HISTORIC AND DESIGN REVIEW COMMISSION

April 03, 2019

HDRC CASE NO: 2019-082
ADDRESS: 931 HAYS ST
LEGAL DESCRIPTION: NCB 1654 BLK B LOT S 140 FT OF 16
ZONING: R-5, H
CITY COUNCIL DIST.: 2
DISTRICT: Dignowity Hill Historic District
APPLICANT: Adam Sanchez
OWNER: Adam Sanchez, Adam Sanchez
TYPE OF WORK: Construction of 2-story residential structure
APPLICATION RECEIVED: March 14, 2019
60-DAY REVIEW: May 13, 2019
CASE MANAGER: Edward Hall
REQUEST:

The applicant is requesting a Certificate of Appropriateness for approval to construct a new, 2-story residential structure on the vacant lot at 931 Hays, located within the Dignowity Hill Historic District.

1 SITE PLAN
1/8" = 1'-0"

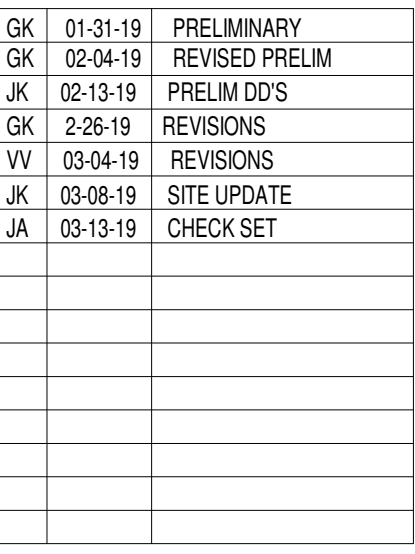
- b. CONCEPTUAL APPROVAL – This request received conceptual approval on March 6, 2019, with the following stipulations:
 - That the applicant incorporate a setback that is equal to or greater than those found historically on the block, for both the primary and accessory structures. A setback plan showing those found historically on the block should be submitted to confirm the proposed setback's appropriate. **The applicant has provided an update site plan which notes a setback that matches that of the neighboring historic structure.**

- c. SETBACKS & ORIENTATION – According to the Guidelines for New Construction, the front facades of new buildings are to align with front facades of adjacent buildings where a consistent setback has been established along the street frontage. Additionally, the orientation of new construction should be consistent with the historic examples found on the block. The applicant has proposed an updated setback that matches that of the neighboring historic structure; however, the proposed new construction's setback is greater than other structures on the block.

- d. SETBACKS & ORIENTATION (GARAGE) – The applicant has noted a setback of 5' – 3" from the property line for the side garage structure. Staff finds that the proposed side setback for the garage should be greater than that of primary historic structures which front Muncey.

- i. LOT COVERAGE – Per the Guidelines, the building footprint for new construction should be no more than fifty (50) percent of the size of the total lot area. Per the site plan, staff finds the proposed lot coverage to be appropriate.

- o. **MECHANICAL EQUIPMENT** – Per the Guidelines for New Construction 6. all mechanical equipment should be screened from view at the public right of way. The applicant has proposed to locate the mechanical equipment on the west side of the house to be screened by shrubbery. Staff finds this to be appropriate.
- p. **LANDSCAPING PLAN** – The applicant has noted on the updated site plan that landscaping materials will include sod, shrubbery, a four (4) foot concrete walkway and crushed granite between the proposed driveways off on Muncey Street. Staff finds the proposed landscaping information to be appropriate.

- i. That the applicant incorporate a setback that is equal to or greater than those found historically on the block, for both the primary and accessory structures.

- vii. That the proposed driveway does not feature more than ten (10) feet of continuous paving.

3 RECESSED WINDOW DETAIL
1 1/2" = 1'-0"

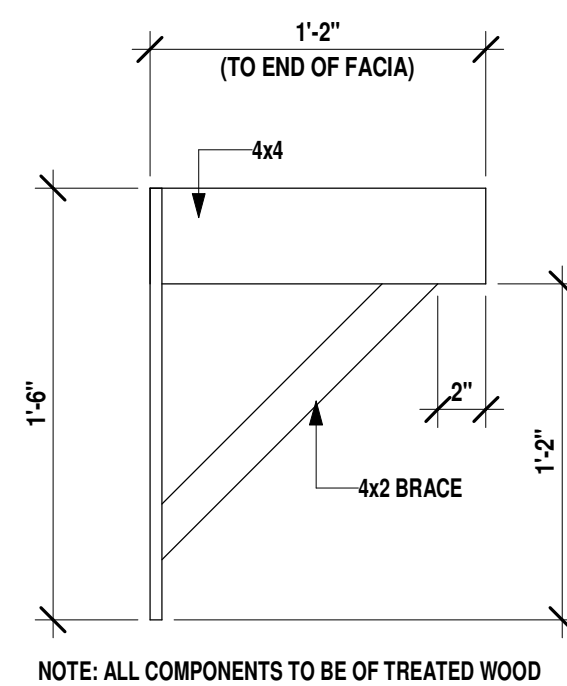
- k. WINDOW MATERIALS – As noted in finding j, the applicant has not provided information regarding window materials. Wood or aluminum clad wood windows are recommended and should feature an inset of two (2) inches within facades and should feature profiles that are found historically within the immediate vicinity. An alternative window material may be proposed provided that the window features meeting rails that are no taller than 1.25" and stiles no wider than 2.25". White manufacturer's color is not allowed, and color selection must be presented to staff. There should be a minimum of two inches in depth between the front face of the window trim and the front face of the top window sash. This must be accomplished by recessing the window sufficiently within the opening or with the installation of additional window trim to add thickness. Window trim must feature traditional dimensions and an architecturally appropriate sill detail. Window track components must be painted to match the window trim or concealed by a wood window screen set within the opening.

- iv. That all siding feature a smooth finish and that all battens feature a width of 1 – ½”.
- v. That wood or aluminum clad wood windows be installed that feature an inset of two (2) inches within facades and should feature profiles that are found historically within the immediate vicinity. An alternative window material may be proposed provided that the window features meeting rails that are no taller than 1.25” and stiles no wider than 2.25”. White manufacturer’s color is not allowed, and color selection must be presented to staff. There should be a minimum of two inches in depth between the front face of the window trim and the front face of the top window sash. This must be accomplished by recessing the window sufficiently within the opening or with the installation of additional window trim to add thickness. Window trim must feature traditional dimensions and an architecturally appropriate sill detail. Window track components must be painted to match the window trim or concealed by a wood window screen set within the opening.
